Please share your comments on the proposed Rochester Natural Gas Pipeline Project

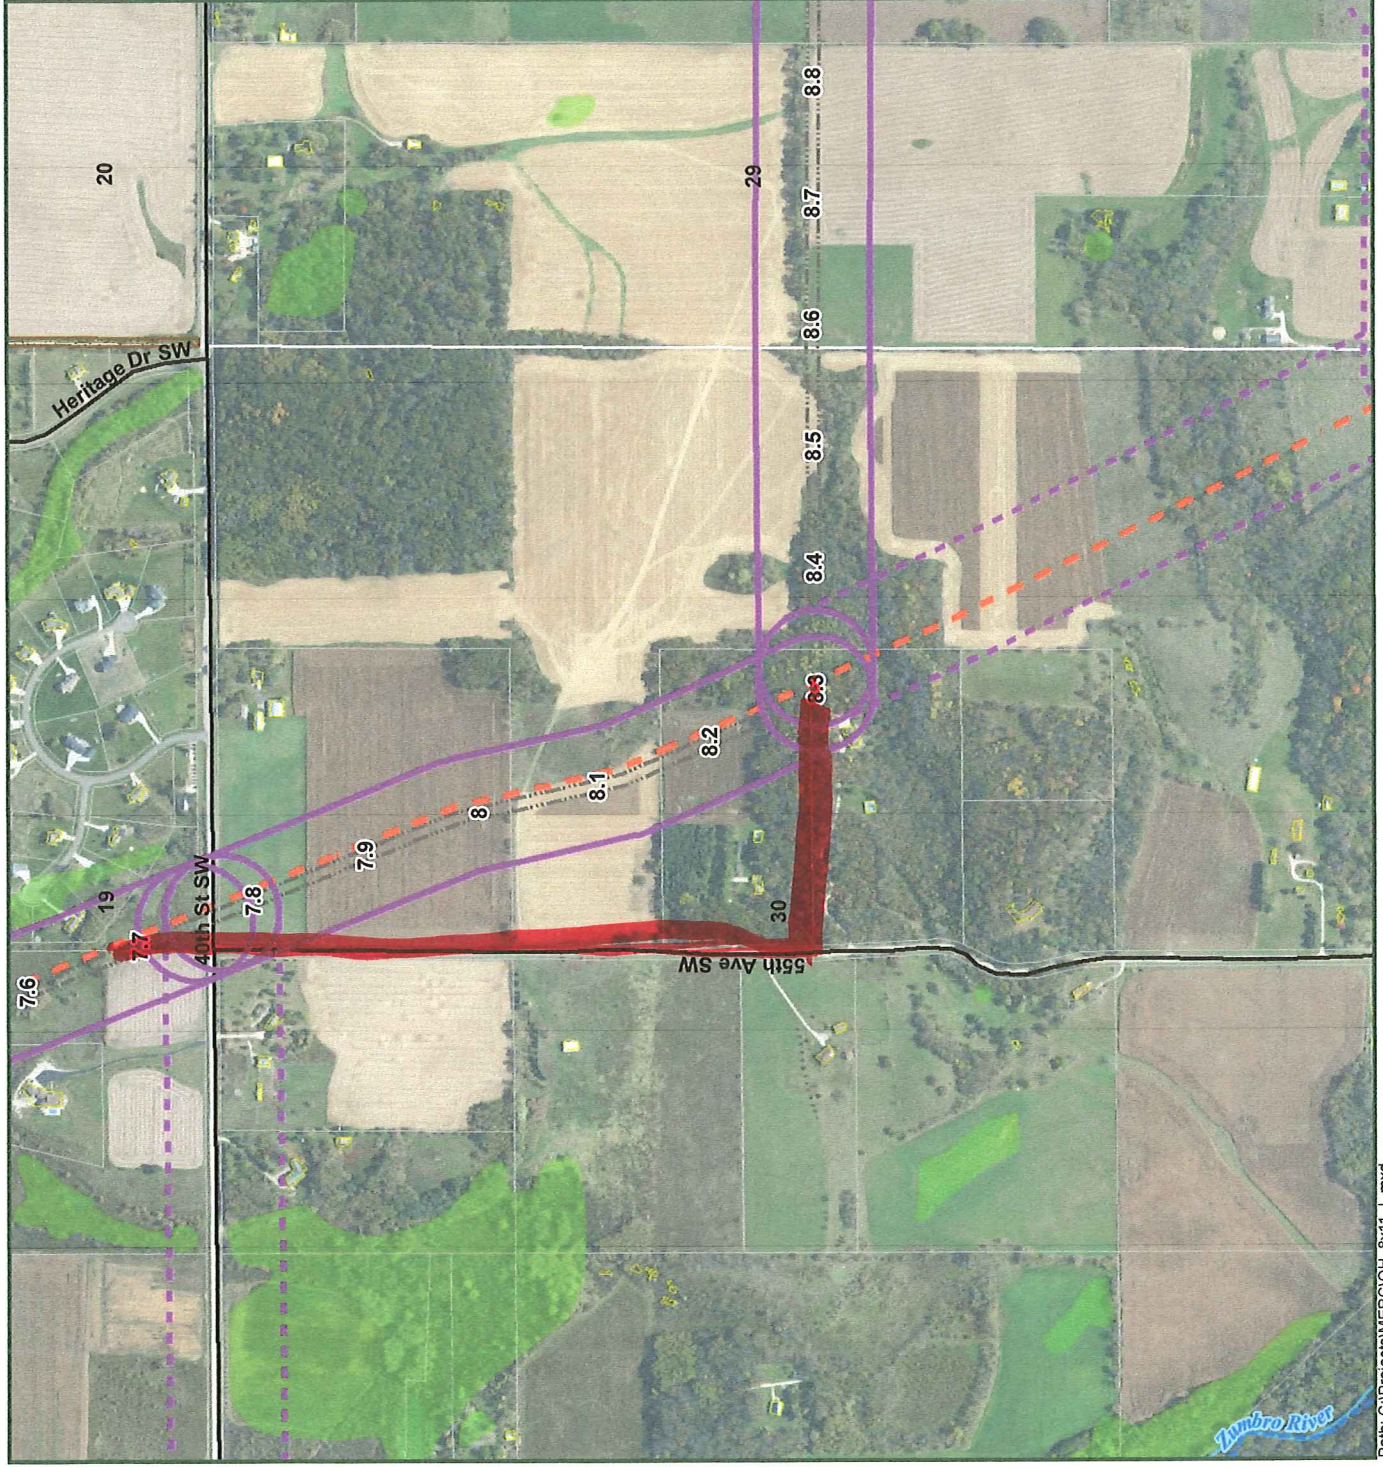
We would like to see the pipeline extended
to 55 Ave. go along 55 Av. N. & connect after
40 st.
